Re: BZA Appeal No 17109. 2nd Remand of Kalorama Citizens Association

THIS SET OF DRAWINGS (PAGES A1-A16) AMENDS AND REVISES THE WORK AT 1819 BELMONT RD., N.W. WHICH IS BEING PERFORMED UNDER THE FOLLOWING GENERAL BUILDING PERMIT NUMBERS:

1819 BELMONT RD., N.W. WASHINGTON, DC 20009	REVISIONS/ADDENDA TO PERMIT(S) AS NOTED 11/10/03
NORMAN SMITH ARCHITECTURE 202.462.5886

LWR LEVEL FLR PLAN
 A2 Scale: 1/8" = 1'-0"

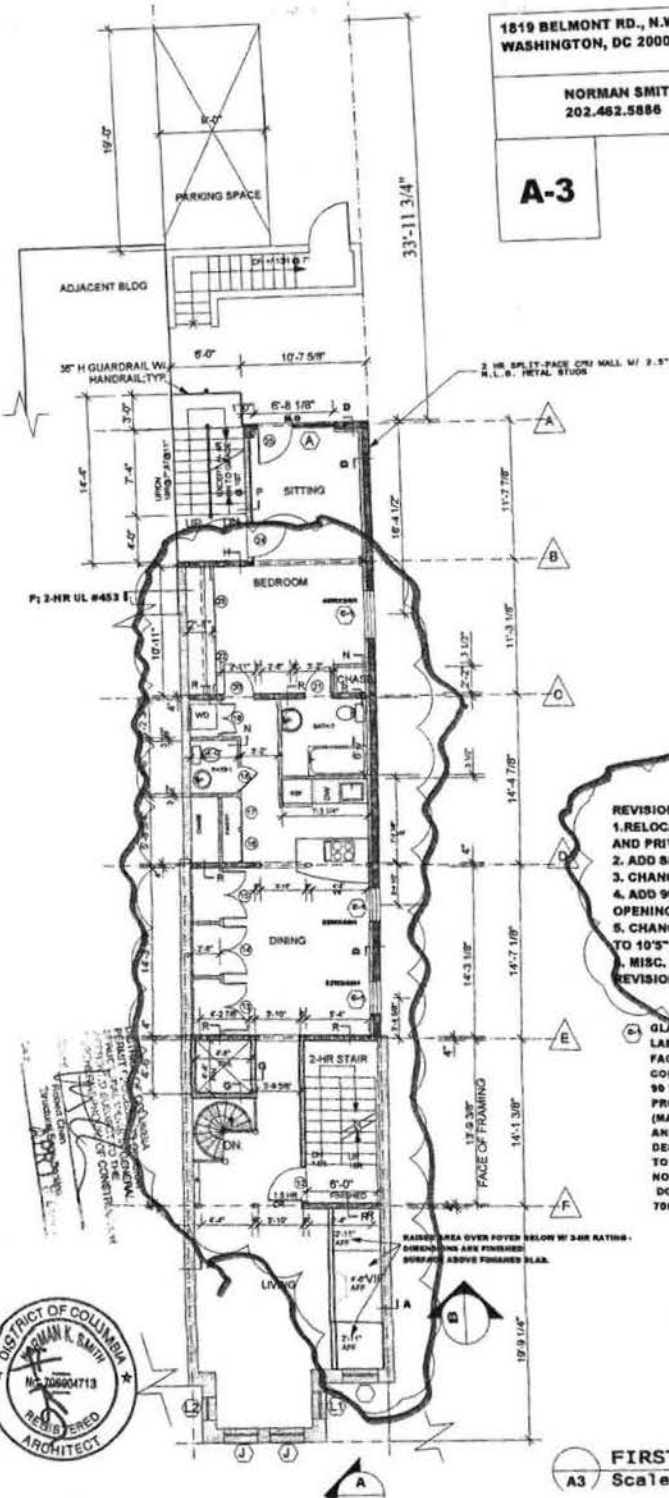
REVISIONS:
 1. RELOCATE EGRESS STAIR TO EAST SIDE AND PRIVATE LIFT TO WEST SIDE.
 2. ADD BATHROOM AND SPIRAL STAIR AT LOWER LEVEL.
 3. REVISE PRIVATE LIFT MOTOR LOCATION

SPIRAL STAIR SUPPORTED AS 4\"/>

SECOND FLOOR PLAN
 Scale: 1/8" = 1'-0"

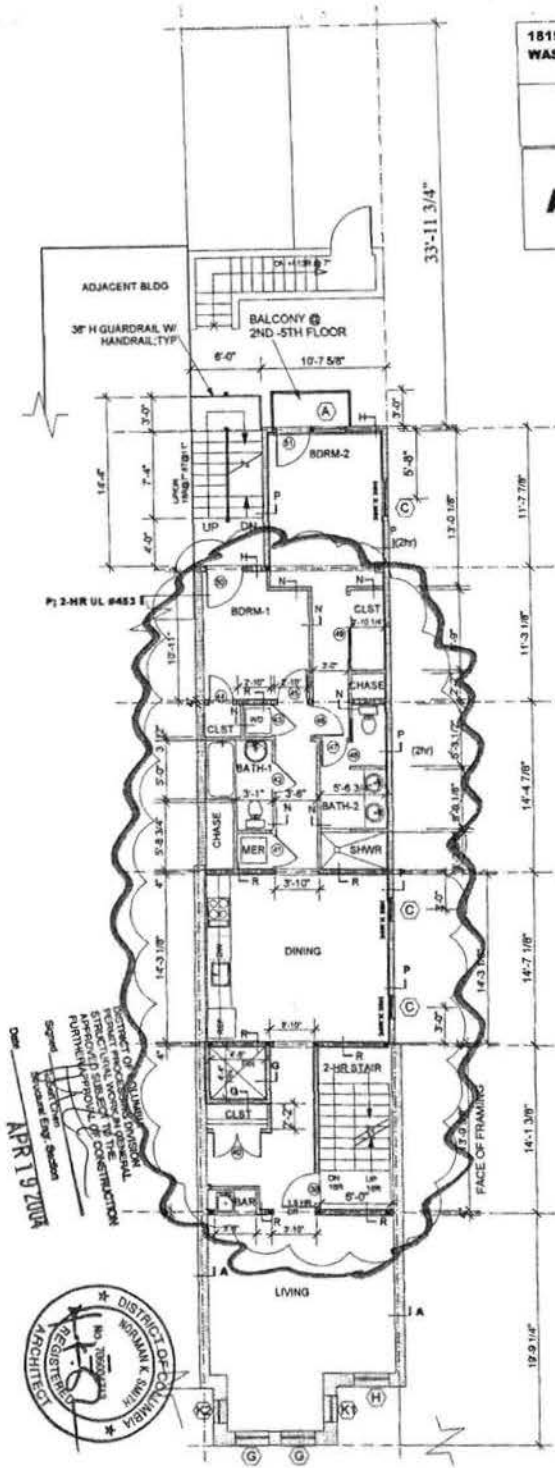
REVISIONS:
 1. RELOCATE EGRESS STAIR TO EAST SIDE AND PRIVATE LIFT TO WEST SIDE.
 2. CHANGE F.O.L. WALL TO 8" CMU (2-HR)
 3. ADD 90 MIN FIRE-RATED GLASS BLOCK OPENINGS
 4. MISC. MINOR INTERIOR N.L.S. PLAN REVISIONS

C-1 GLASS BLOCK, OPENING PROTECTIVE/ LABELED FIRE WINDOW IN 2-HR RATED, FACE-ON-LINE CMU WALL; PITTSBURGH CORNING THICKSET 90 OR VISTABRICK, 90 MIN. RATED GLASS BLOCK OPENING PROTECTIVE PER U.L. # R1559; (MAXIMUM OPENING AREA = MAX. 11 SF AND < THAN 25% OF WALL L.F.) DESIGNED PER 1999 DC AMENDMENTS TO 1996 BOCA AND 1996 BOCA AS NOTED; DC 705.3.3, 705.3.3.4, 705.3.3.5, BOCA 706.3, 719

LWR LEVEL FLR PLAN
 A2 Scale: 1/8" = 1'-0"

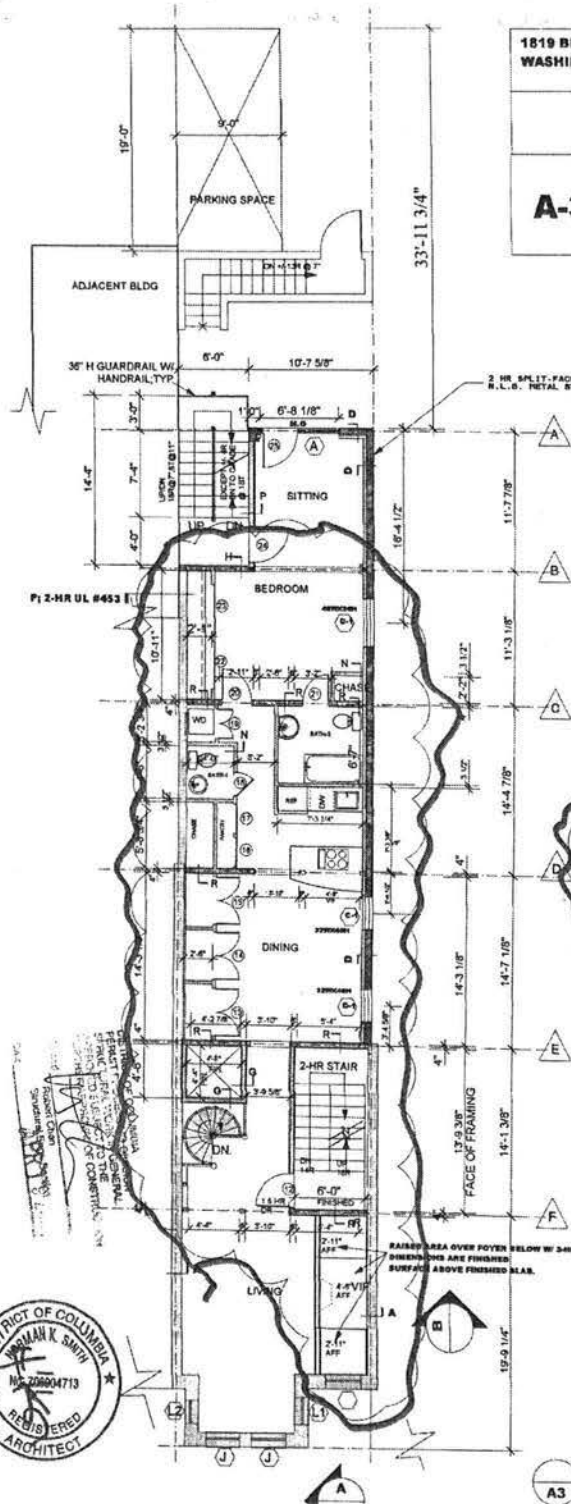
REVISIONS:
 1. RELOCATE EGRESS STAIR TO EAST SIDE AND PRIVATE LIFT TO WEST SIDE.
 2. ADD BATHROOM AND SPIRAL STAIR AT LOWER LEVEL.
 3. REVISE PRIVATE LIFT MOTOR LOCATION

Handwritten note: SPIRAL STAIR SUPPORTED ON 4" CONC. SLAB @ LWR LVL. *Signature:* [Signature]

FIRST FLOOR PLAN
A3 Scale: 1/8" = 1'-0"

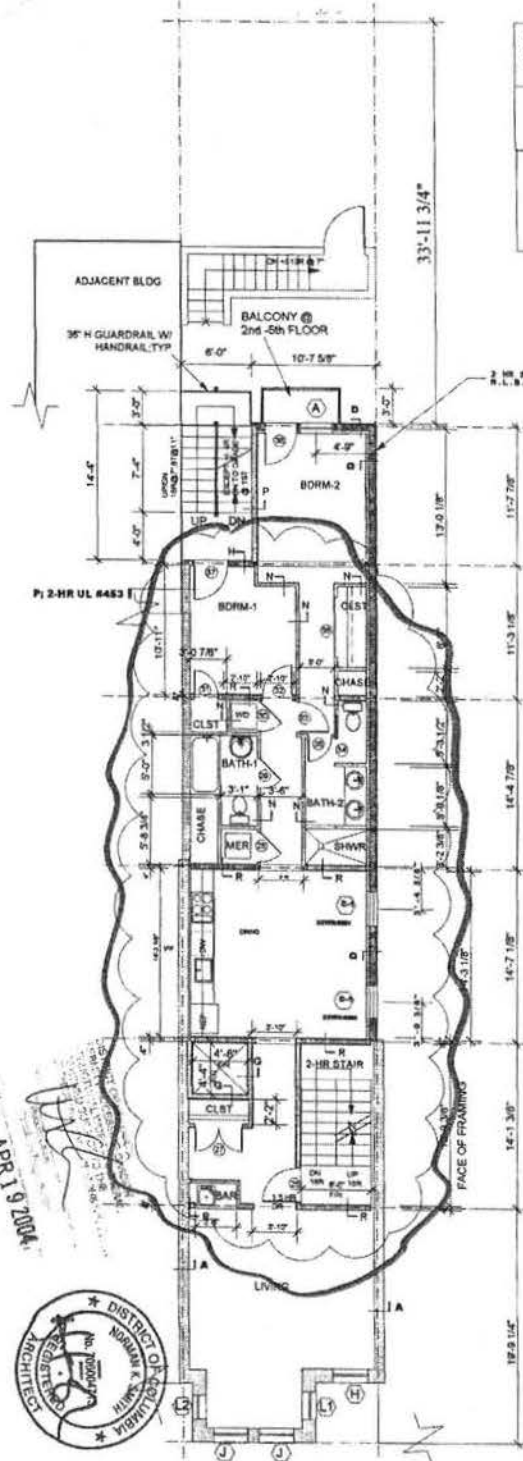
- REVISIONS:**
1. RELOCATE EGRESS STAIR TO EAST SIDE AND PRIVATE LIFT TO WEST SIDE.
 2. ADD SPIRAL STAIR
 3. CHANGE F.O.L. WALL TO 8" CMU (2-HR)
 4. ADD 90 MIN FIRE-RATED GLASS BLOCK OPENINGS
 5. CHANGE FOYER/ENTRY CEILING HEIGHT TO 10'3" +/-
 6. MISC. MINOR INTERIOR N.L.B. PLAN REVISIONS

GLASS BLOCK, OPENING PROTECTIVE/LABELED FIRE WINDOW IN 2-HR RATED, FACE-ON-LINE CMU WALL; PITTSBURGH CORNING THICKSET 90 OR VISTABRICK, 90 MIN. RATED GLASS BLOCK OPENING PROTECTIVE PER U.L. # R2556; (MAXIMUM OPENING AREA = MAX. 11 SF AND < THAN 25% OF WALL L.F.) DESIGNED PER 1999 DC AMENDMENTS TO 1996 BOCA AND 1996 BOCA AS NOTED: DC 705.3.3, 705.3.3.4, 705.3.3.5, BOCA 706.3, 719

ⓐ SECOND FLOOR PLAN
 Scale: 1/8" = 1'-0"

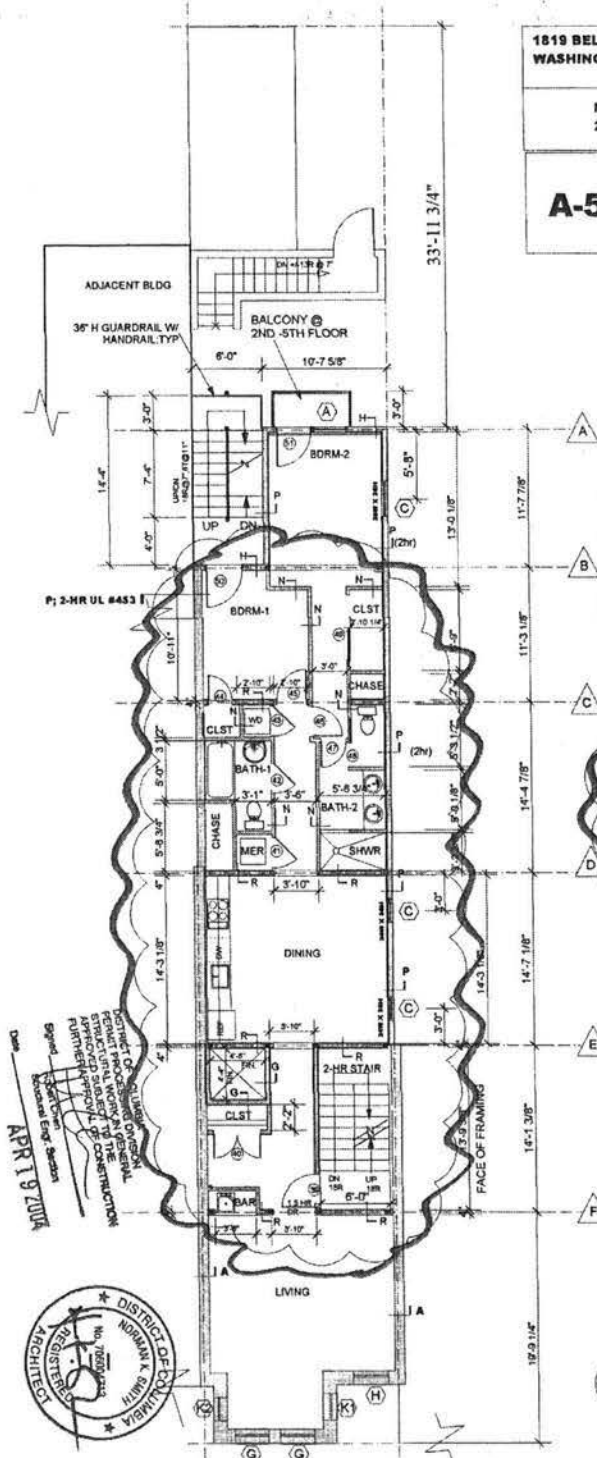
- REVISIONS:**
1. RELOCATE EGRESS STAIR TO EAST SIDE AND PRIVATE LIFT TO WEST SIDE.
 2. CHANGE F.O.L. WALL TO 8" CMU (2-HR)
 3. ADD 90 MIN FIRE-RATED GLASS BLOCK OPENINGS
 4. MISC. MINOR INTERIOR N.L.B. PLAN REVISIONS

ⓐ GLASS BLOCK, OPENING PROTECTIVE/
 LABELED FIRE WINDOW IN 2-HR RATED,
 FACE-ON-LINE CMU WALL; PITTSBURGH
 CORNING THICKSET 90 OR VISTABRICK,
 90 MIN. RATED GLASS BLOCK OPENING
 PROTECTIVE PER U.L. # R2530;
 (MAXIMUM OPENING AREA = MAX. 11 SF
 AND < THAN 25% OF WALL L.F.)
 DESIGNED PER 1998 DC AMENDMENTS
 TO 1998 BOCA AND 1998 BOCA AS
 NOTED:
 DC 705.3.3, 705.3.3.4, 705.3.3.5, BOCA
 705.3, 719

THIRD FLOOR PLAN
 Scale: 1/8" = 1'-0"

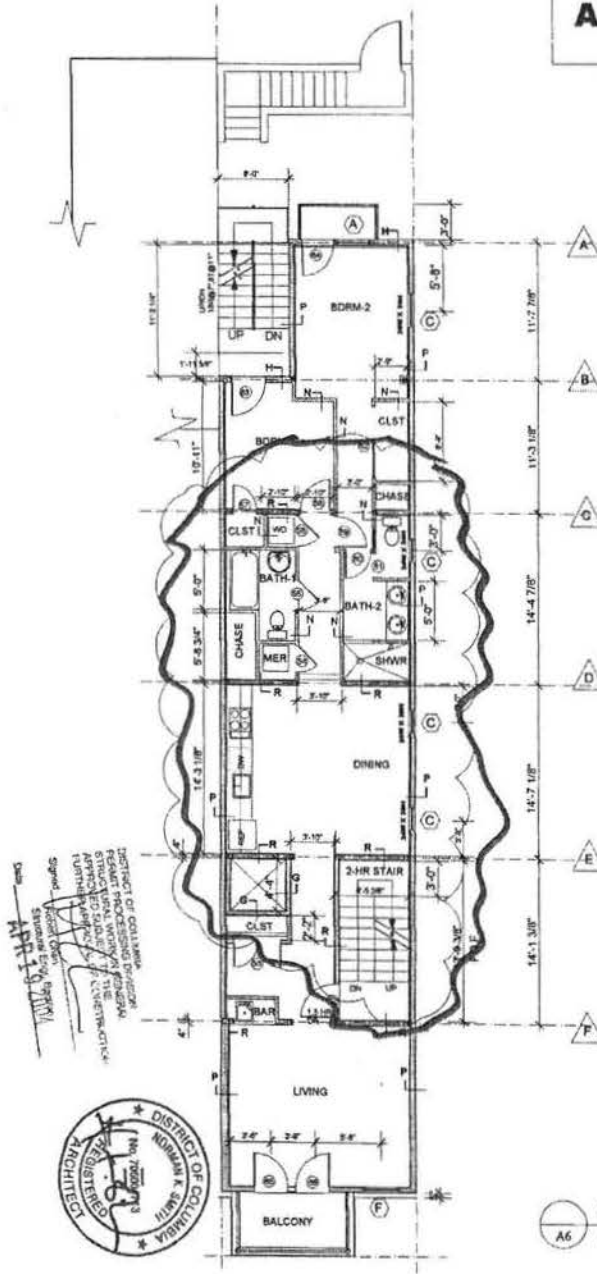
- REVISIONS:**
1. RELOCATE EGRESS STAIR TO EAST SIDE AND PRIVATE LIFT TO WEST SIDE.
 2. ADD 90 MIN FIRE RATED OPENING PROTECTIVE/FIRE WINDOW
 3. MISC. MINOR INTERIOR N.L.B. PLAN REVISIONS
 4. CH-ANGE EXTERIOR N.L.B. WALL FROM 2-HR UL# U424 TO 2-HR UL# U-453 (WALL TYPE P)

(C) 1" TECHNICAL GLASS PRODUCTS (TG) IN MANUFACTURER'S RATED STEEL FRAME AS 90 MINUTE FIRE RATED OPENING PROTECTIVE/FIRE WINDOW IN 2 HOUR RATED FACE-ON-LINE N.L.B. STEEL STUD WALL. DESIGNED PER 1996 DC AMENDMENTS TO 1998 BOCA AND 1998 BOCA AS NOTED; DC 705.3.3, 705.3.3.4, 705.3.3.5, BOCA 706.3, 719

FOURTH FLOOR PLAN
 A6 Scale: 1/8" = 1'-0"

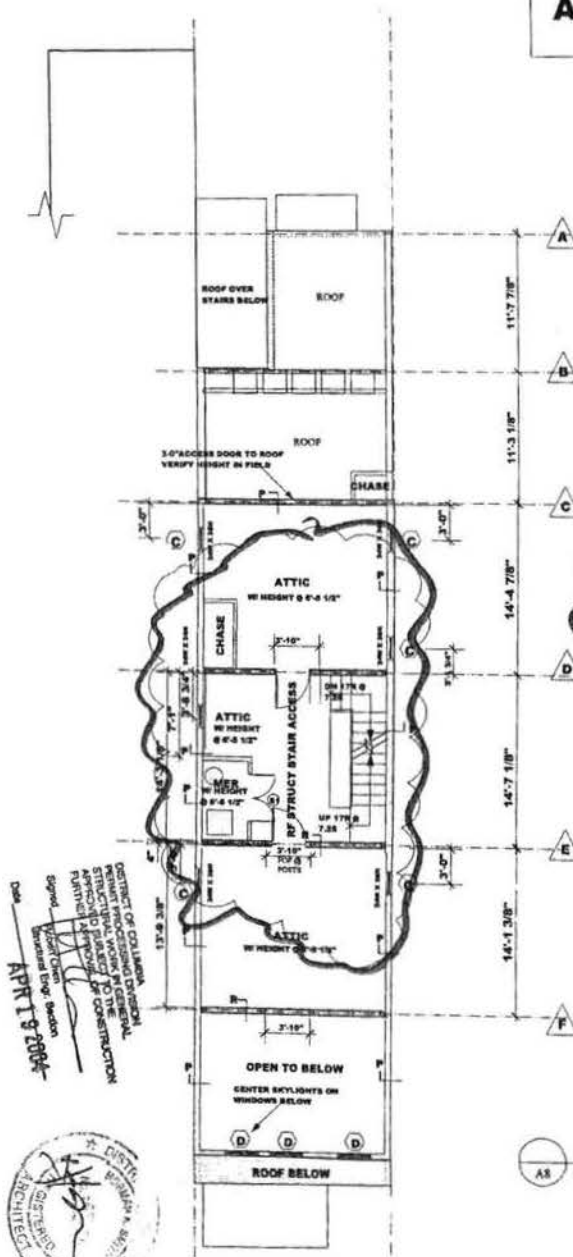
REVISIONS:
 1. RELOCATE EGRESS STAIR TO EAST SIDE AND PRIVATE LIFT TO WEST SIDE.
 2. ADD 90 MINUTE FIRE RATED OPENING PROTECTIVE FIRE WINDOW
 3. MISC. MINOR INTERIOR N.L.B. PLAN REVISIONS
 4. CHANGE EXTERIOR N.L.B. WALL FROM 2-HR ULB U424 TO 2-HR ULB U-453 (WALL TYPE P)

C 1" TECHNICAL GLASS PRODUCTS IGU IN MANUFACTURER'S RATED STEEL FRAME AS 90 MINUTE FIRE RATED OPENING PROTECTIVE FIRE WINDOW IN 2 HOUR RATED FACE-ON-LINE N.L.B. STEEL STUD WALL. DESIGNED PER 1996 DC AMENDMENTS TO 1996 BOCA AND 1996 BOCA AS NOTED: DC 705.3.2, 705.3.3.4, 705.3.3.5, BOCA 705.3, 719

ATTIC PLAN
 AS Scale: 1/8" = 1'-0"

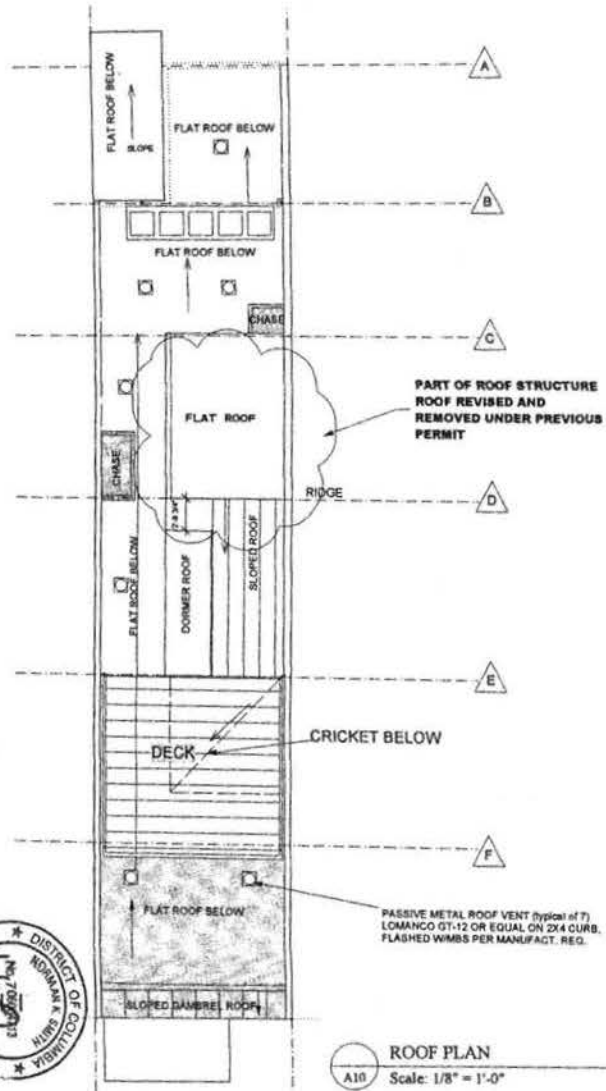
- REVISIONS:**
- 1.ADD 90 MINUTE FIRE RATED OPENING PROTECTIVE/FIRE WINDOW
 - 2.RELOCATE MER TO ATTIC; NO CHANGE IN FAR
 3. MISC. MINOR INTERIOR N.L.B. PLAN REVISIONS
 4. CHANGE EXTERIOR N.L.B. WALL FROM 2-HR ULS U424 TO 2-HR ULS U-453 (WALL TYPE P)

C 1" TECHNICAL GLASS PRODUCTS IOU IN MANUFACTURER'S RATED STEEL FRAME AS 90 MINUTE FIRE RATED OPENING PROTECTIVE/FIRE WINDOW IN 2 HOUR RATED FACE-ON-LINE N.L.B. STEEL STUD WALL. DESIGNED PER 1999 DC AMENDMENTS TO 1996 BOCA AND 1994 BOCA AS NOTED: DC 705.3.3, 705.3.3.4, 705.3.3.5, BOCA 706.3, 719

WEST ELEVATION

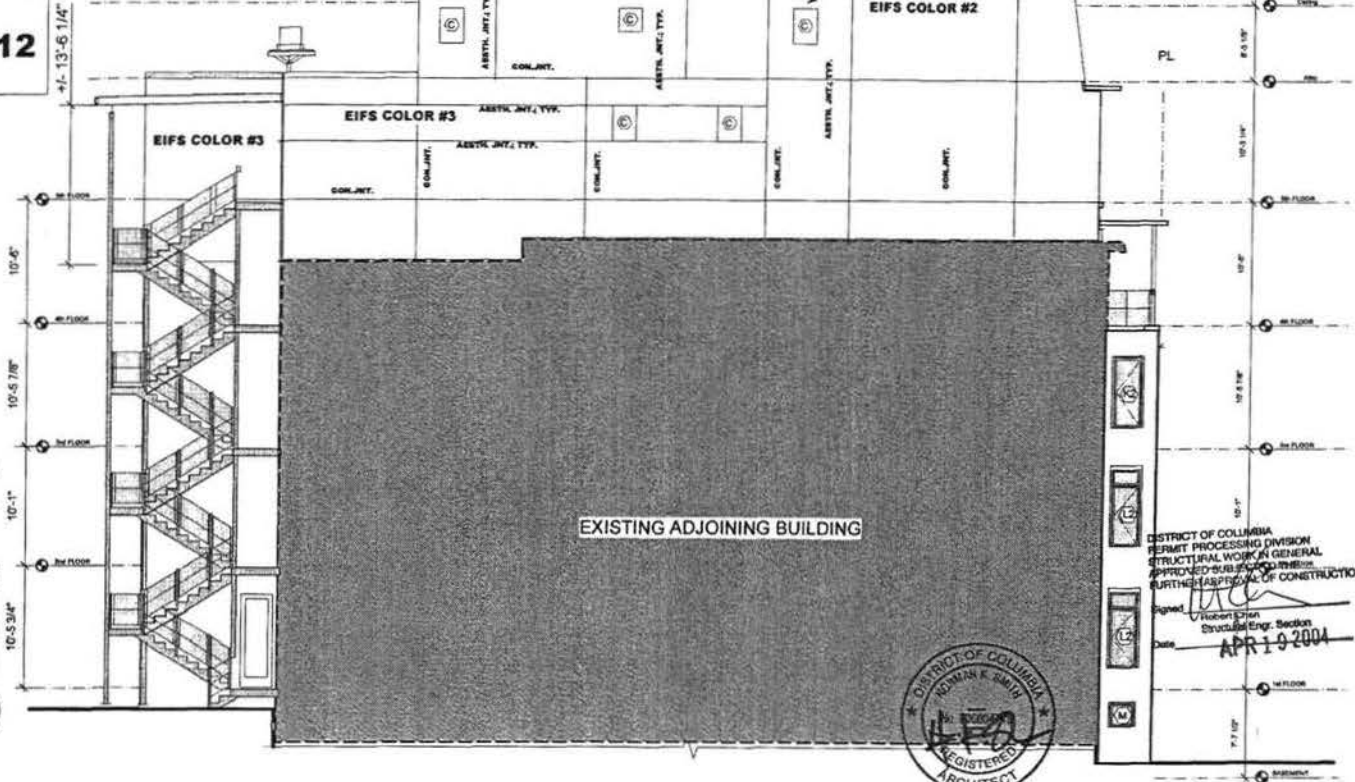
PART OF ROOF STRUCTURE
REVISED AND REMOVED
UNDER PREVIOUS PERMIT

1" TECHNICAL GLASS PRODUCTS IGU IN MANUFACTURER'S
RATED STEEL FRAME AS 90 MINUTE FIRE RATED OPENING
PROTECTIVE FIRE WINDOW IN 2 HOUR RATED FACE-ON-LINE
N.L.B. STEEL STUD WALL. TYPICAL OF 5 UNITS THIS
ELEVATION
